May 7, 2025 (rev 06/02/2025)

**Re: M-1977-573 - West Pueblo Pit – TR07 Request Letter**

**Exhibit F**  
**Reclamation Plan Map**

**EXHIBIT F**  
**M1977-573 - TR07**

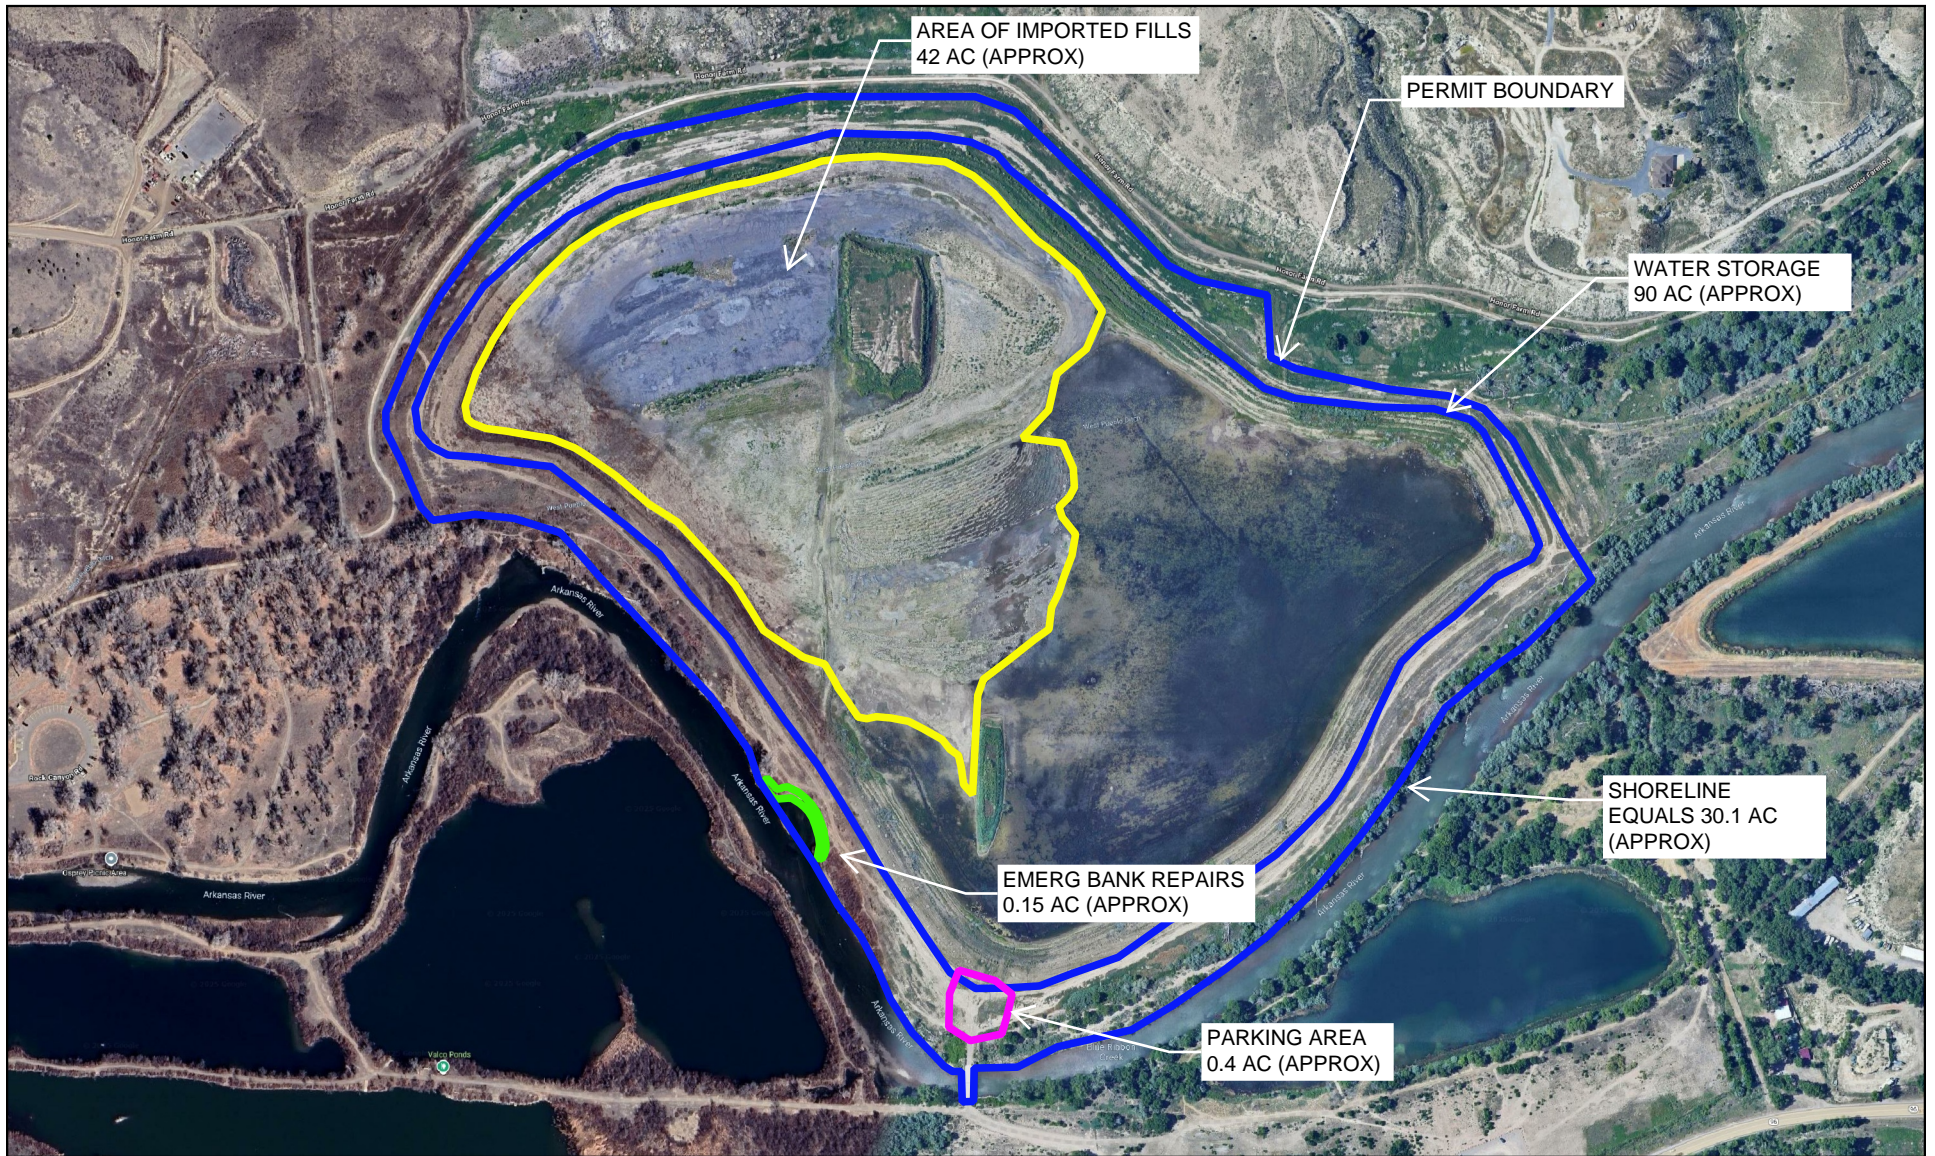
AGRA is submitting a technical revision to the reclamation plan for permit no. M1977-573 to account for imported fills from the construction of a water project by Colorado Springs Utilities and for the construction of emergency repairs to the riverbank at the western edge of the Pit due to scour caused by a faulty fish structure in the Arkansas River near the bank. Per the requirements set forth in the Mineral Rules and Regulations of the Colorado Mined Land Reclamation Board for the Extraction of Construction Materials, Sections 6.4.5 and 6.4.6, Exhibits E and F are being submitted to DRMS to update the reclamation plan for this permit to address these issues.
